ADDENDUM

Project:	Intermountain Health Riverton Hospital GI ASC 374 W 12600 S Riverton, UT 84065
----------	---

Addendum Number:	2
------------------	---

Revision: Addendum #02

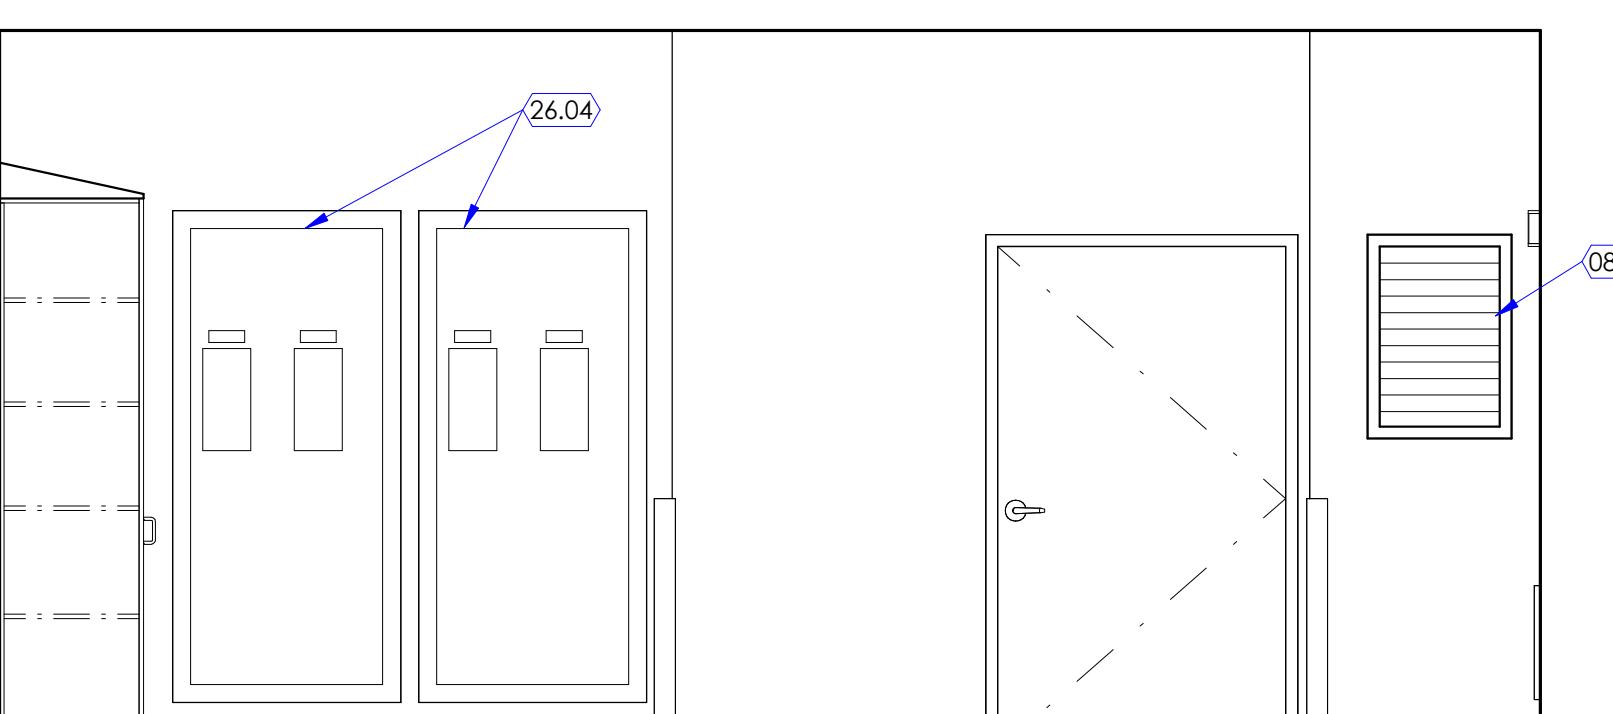
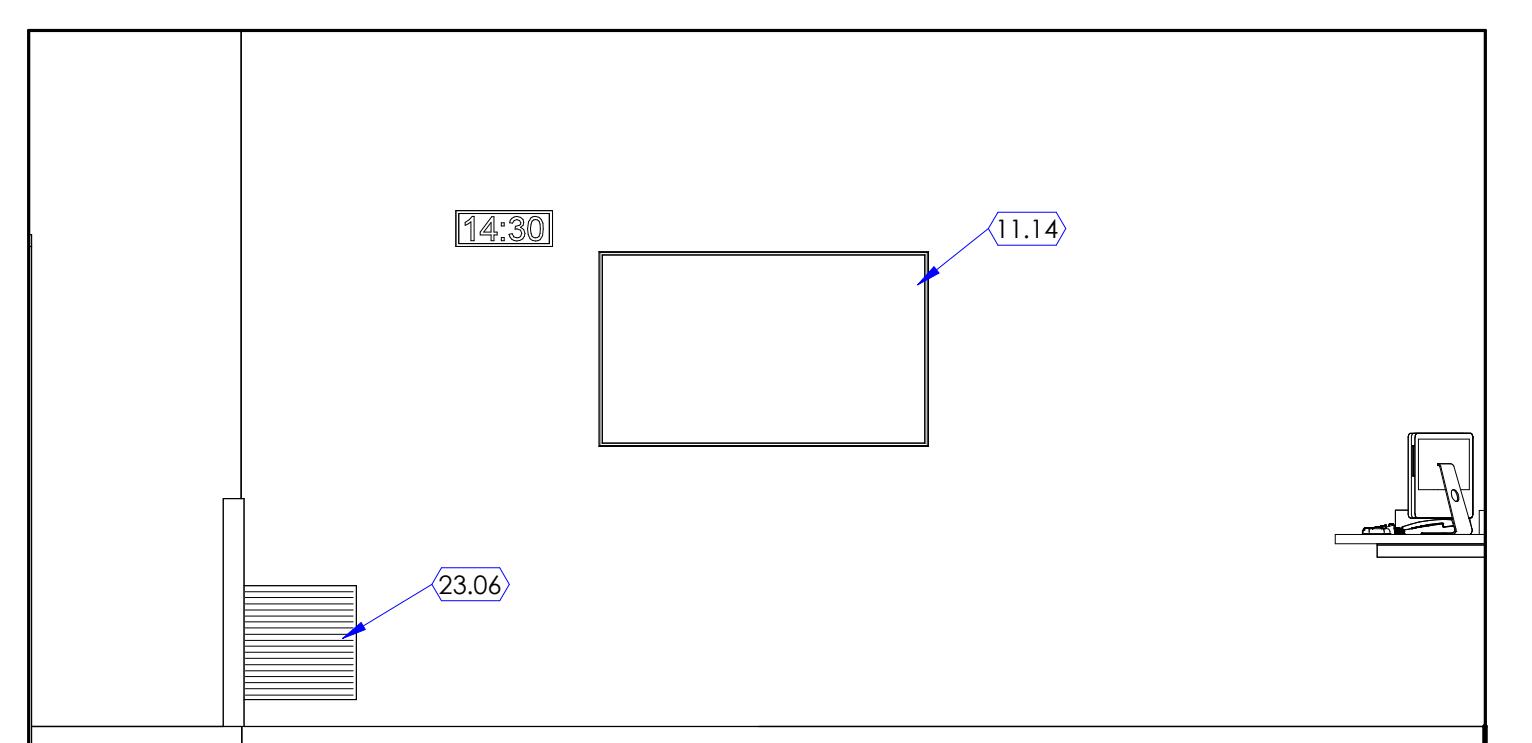
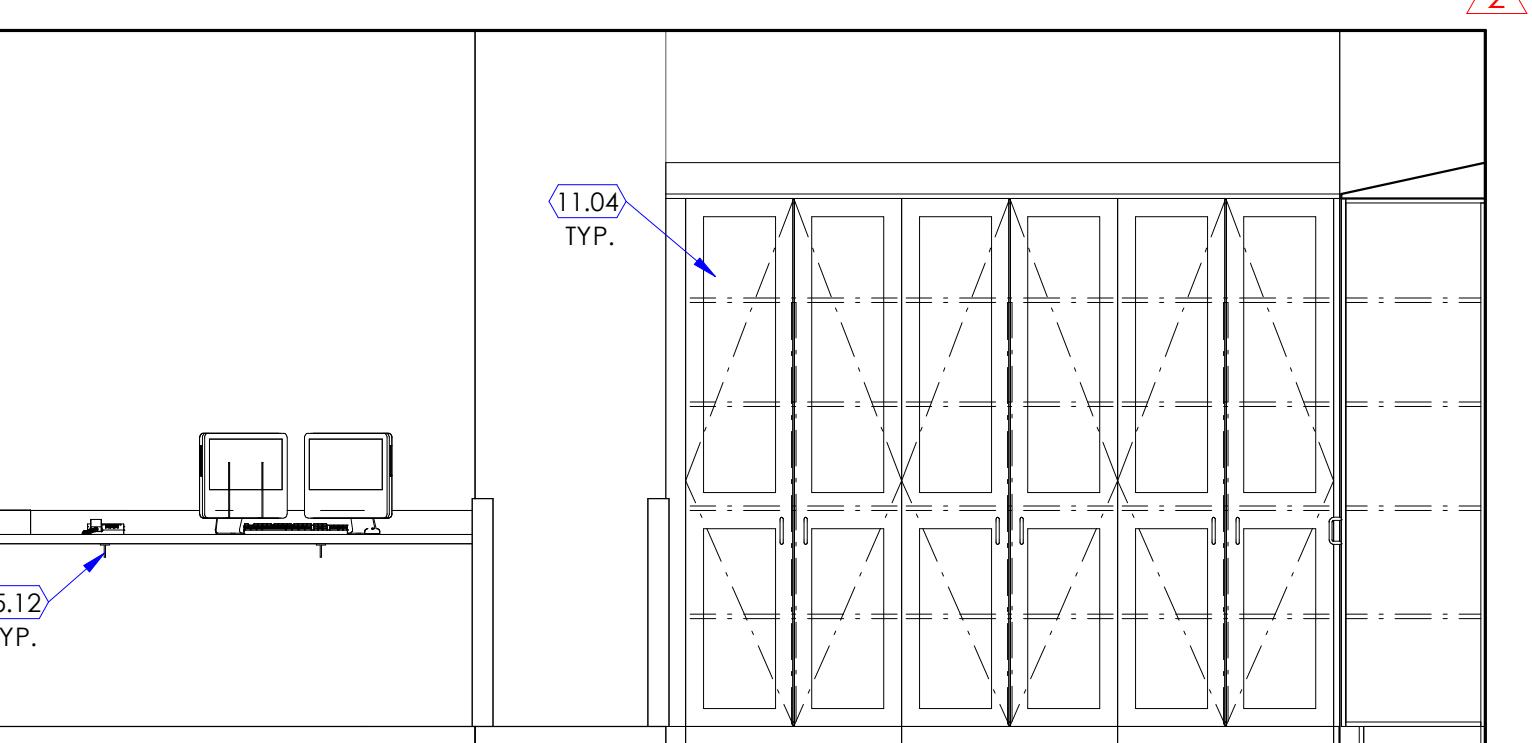
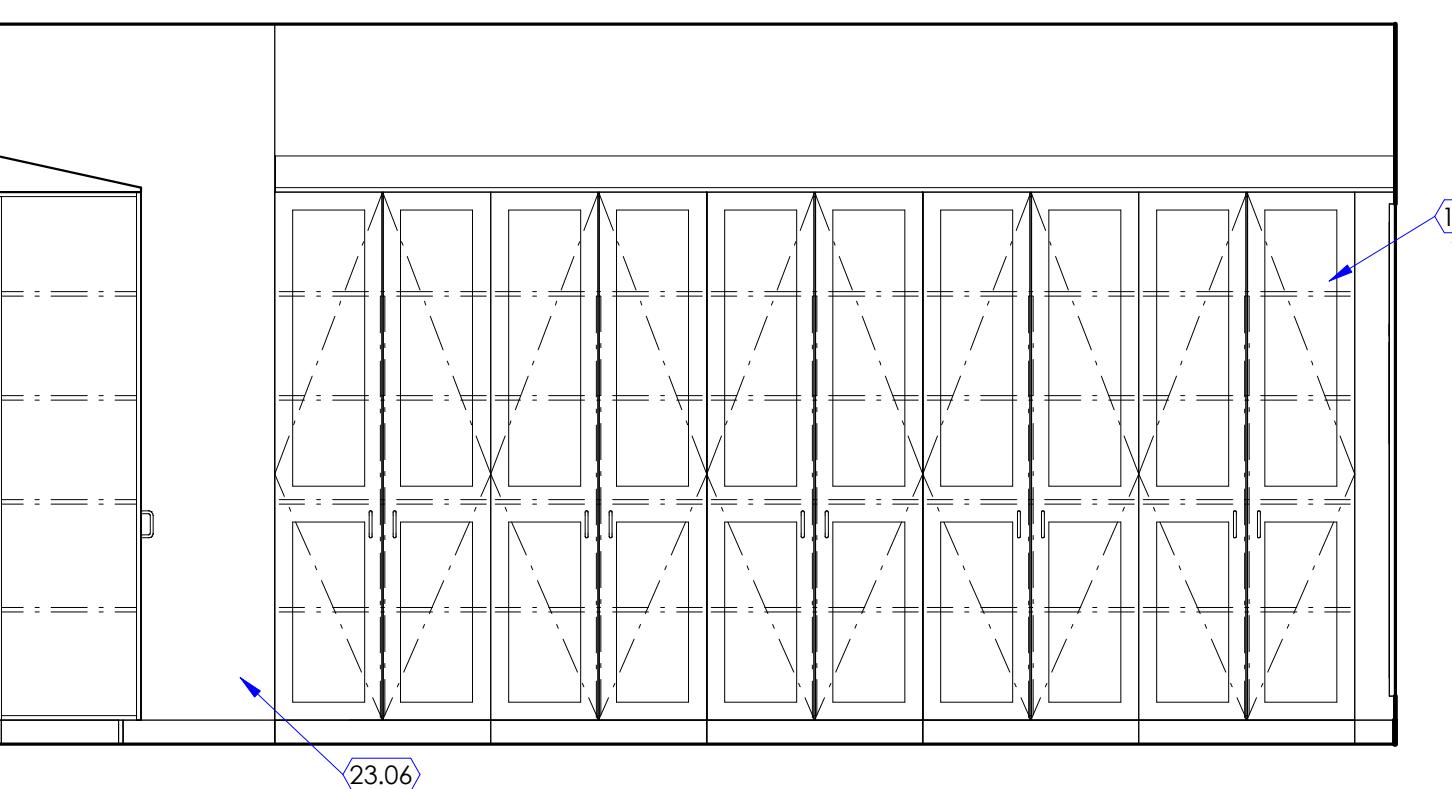
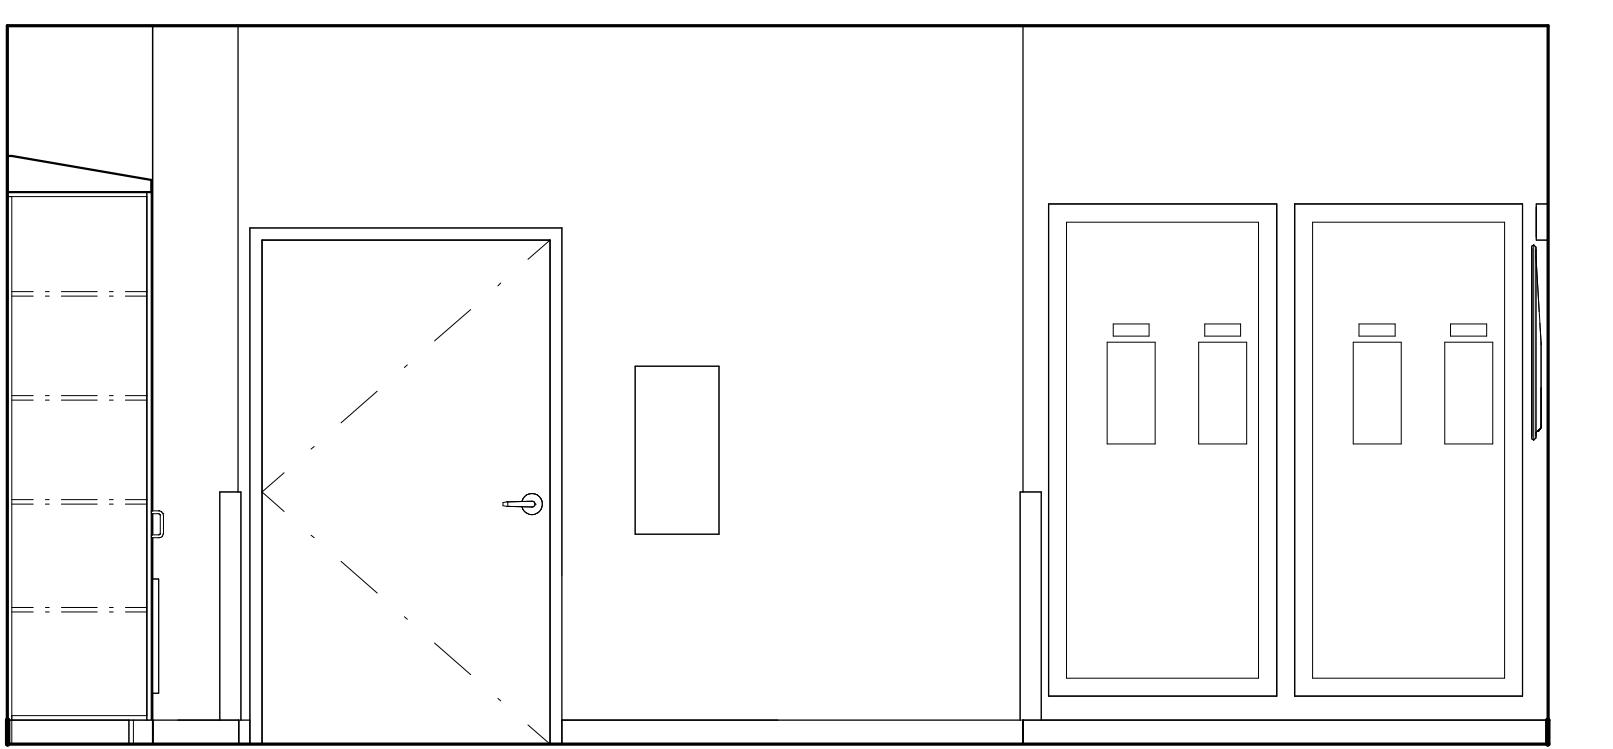
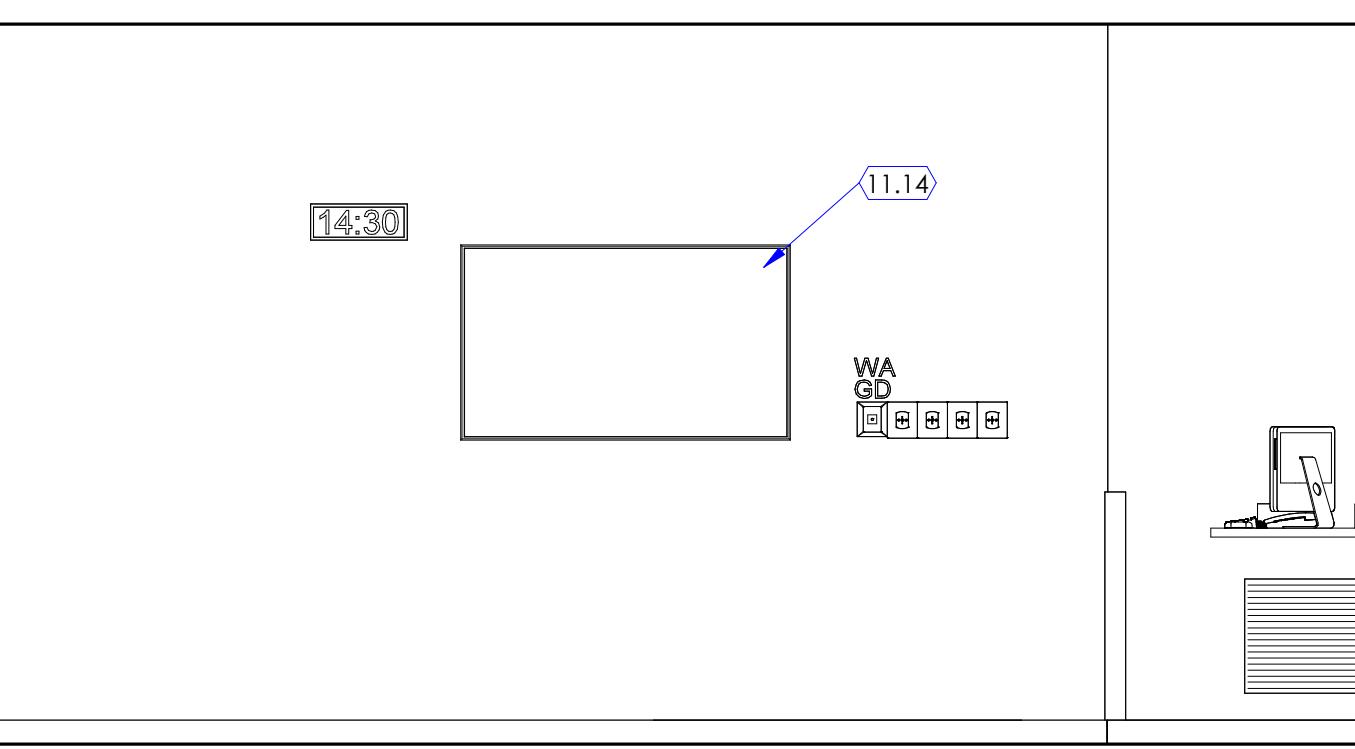
Item Number	General Items Description
1	<p>Q. Regarding the integral blind windows, there is no specific verbiage about lead glass in note 08.03 on the interior elevations or on the window schedule in detail 4 / A601A. However there is note 09.02 on the OR Enlarged Plans on sheet A401 calling for lead lined walls that encapsulates the window. Please verify that window type 1 in OR 2 requires lead lined glass. And that the window in OR 1 will not require lead glass.</p> <p>A. Provide lead lined glass unit and lead lined hollow metal frame for OR 2 window. See attached sheets A401, A402, A601A. No lead lined glass or lead lined frame is required for OR 1 window.</p>
2	<p>Q. The plans call out to match existing ceiling tile. Can you please provide what the existing ceiling tile is?</p> <p>A. Existing ceiling as Ultima Heath Zone. See attached sheet A603A.</p>
3	<p>Q. Unicel does not offer a lead lined perimeter frame. They can provide an aluminum frame that is not lead lined with an insulated integral blind unit with lead equivalent glass in it. Another option would be to have a lead lined Hollow metal frame provided by others and we would only provide the insulated integral blind unit with lead equivalent glass. Please advise how to proceed.</p> <p>A. For window in OR 2, provide lead lined glass unit and lead lined hollow metal frame. See attached sheets A401, A402, A601A.</p>

4	<p>Q. On the insulated lead equivalent integral blind units, the thumbwheel or crank handle operator for the blinds can only be installed on the opposite side of the lead glass. There will be no way of operating the blinds from the OR side. Please verify that this is acceptable.</p> <p>A. This is acceptable. Provide thumbwheel operator on corridor (non-OR) side.</p>

08.12 OR WINDOW WITH INTEGRAL GLAZING UNIT AND HOLLOW METAL FRAME. EACH LEAD LINED AS REQUIRED TO MATCH ADJACENT WALL LINING. SEE PHYSICISTS REPORT. SEE 4/A601A.

ONE-LINE DIAGRAM

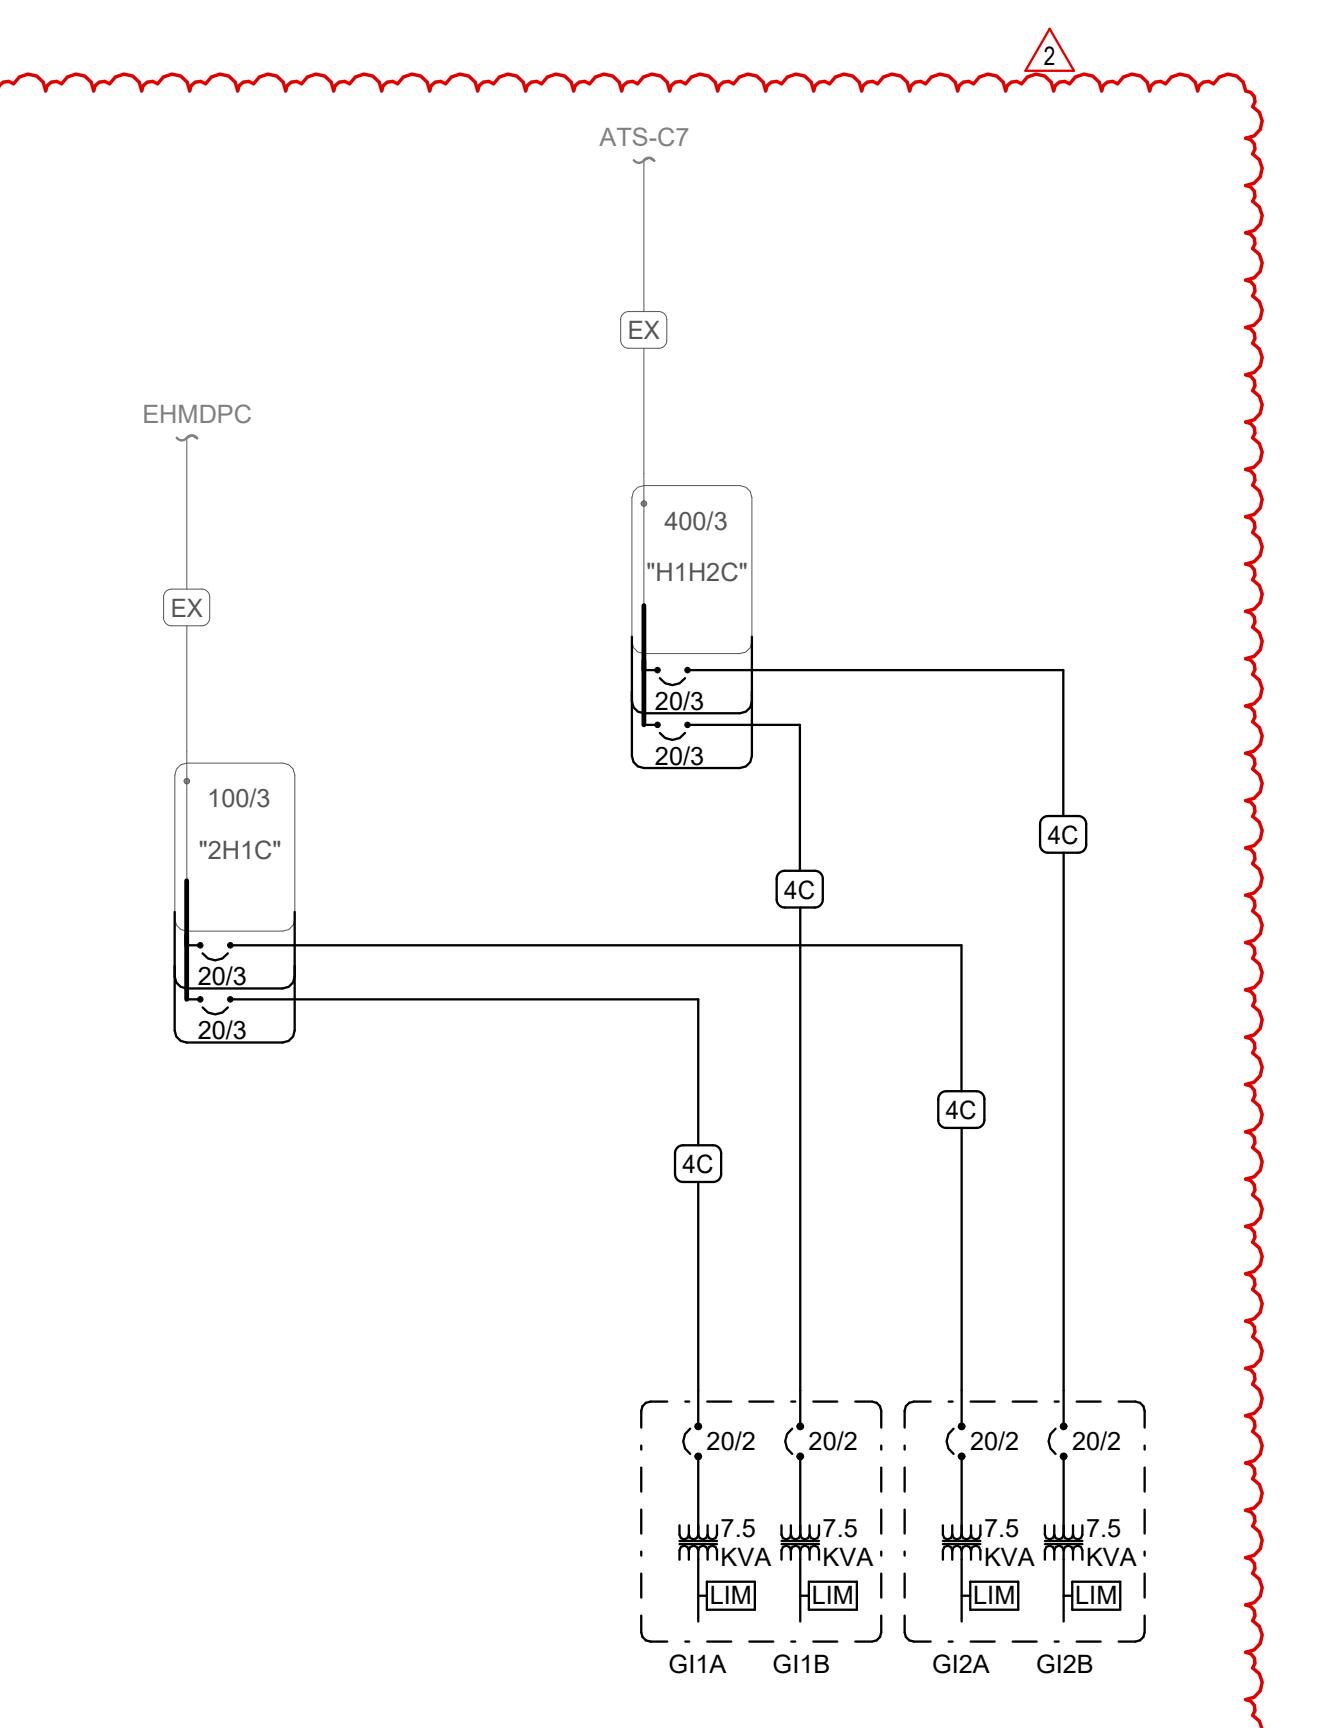
1. We are unable to complete the One-Line without the location of the following equipment: Distribution Board HIDHIC, Panelboard H1H2C. Please provide location for H1DH1C and H1H2C

1. EP601 – One-Line Diagram
 - a. Revised one-line to feed isolation panels from a closer panel.

H1DH1C is no longer being used, the A section of the isolation panels will now be fed from 2H1C which is shown on the plans. H1H2C is located in the first floor electrical room directly below the electrical room shown on sheet EP101A.
